REMARKS/ARGUMENTS

Application No. 10/791,571
Amendment dated February 13, 2006
Reply to Office action of December 5, 2005

FIGURE 10

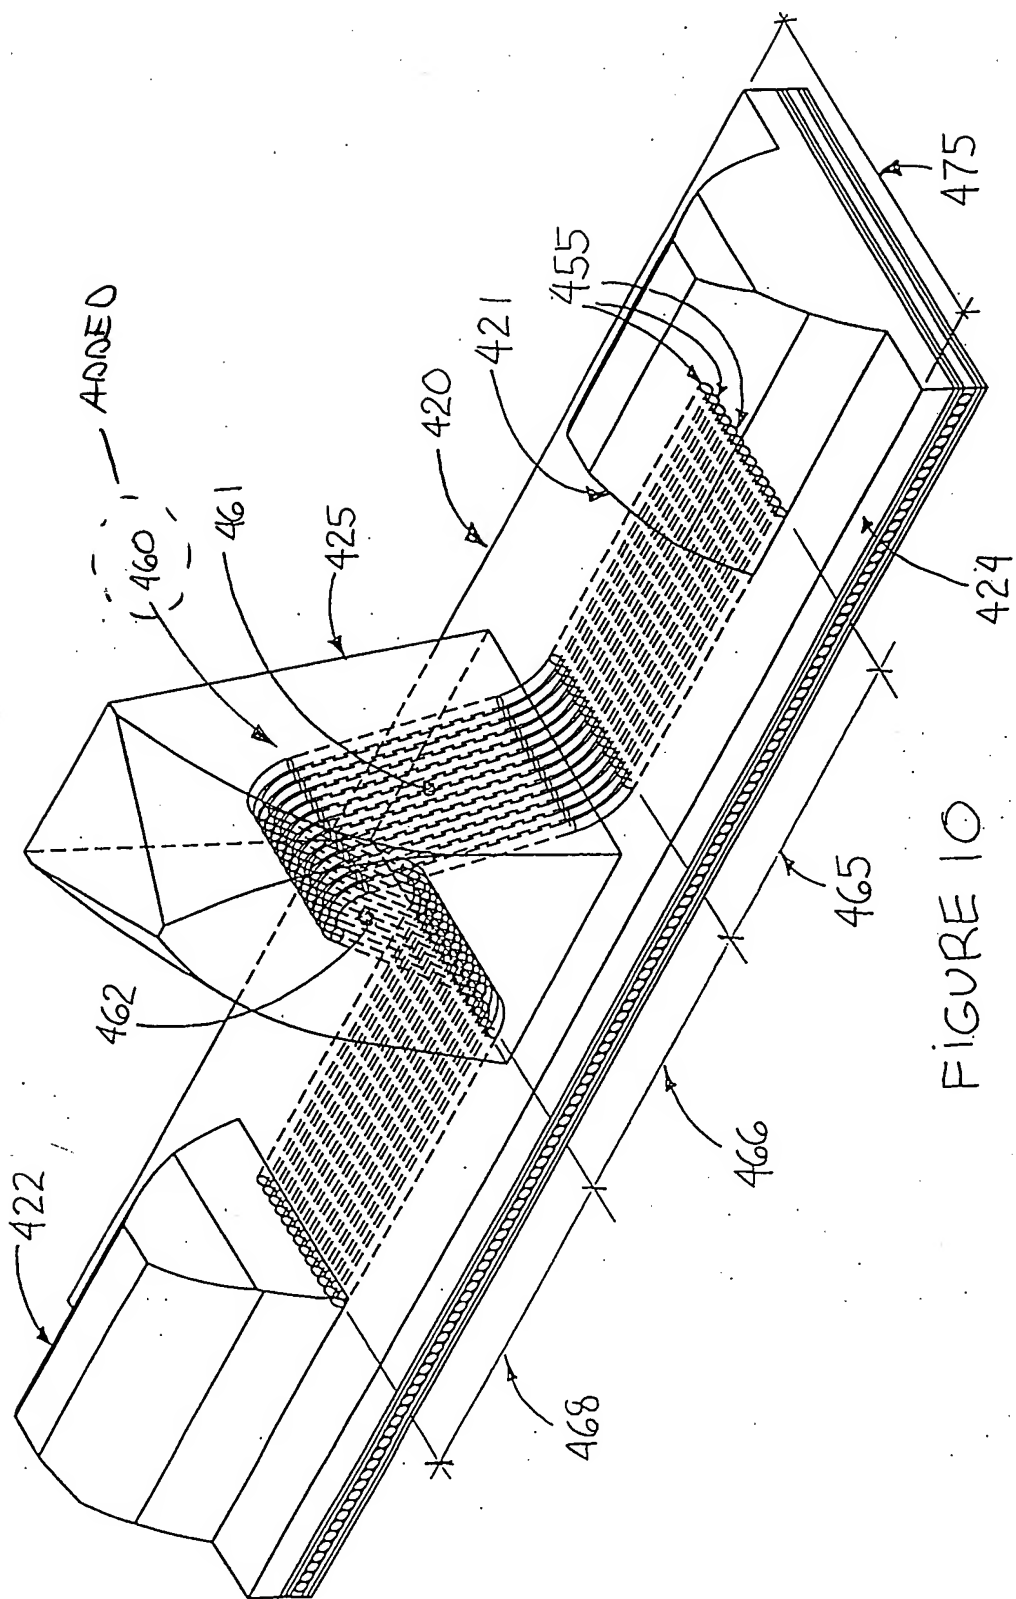
In his examination report, the Examiner has objected the drawings and/or the specification because reference signs appeared in the drawings and not in the specification and vice versa.

More particularly, reference signs 129 and 460 were cited in the specification but were not shown in the drawings. Therefore, the Applicant has removed reference sign 129 from the specification and has added reference sign 460 in Fig. 10.

Encl: Marked-up Figure 10 showing changes;
Replacement Figure 10.
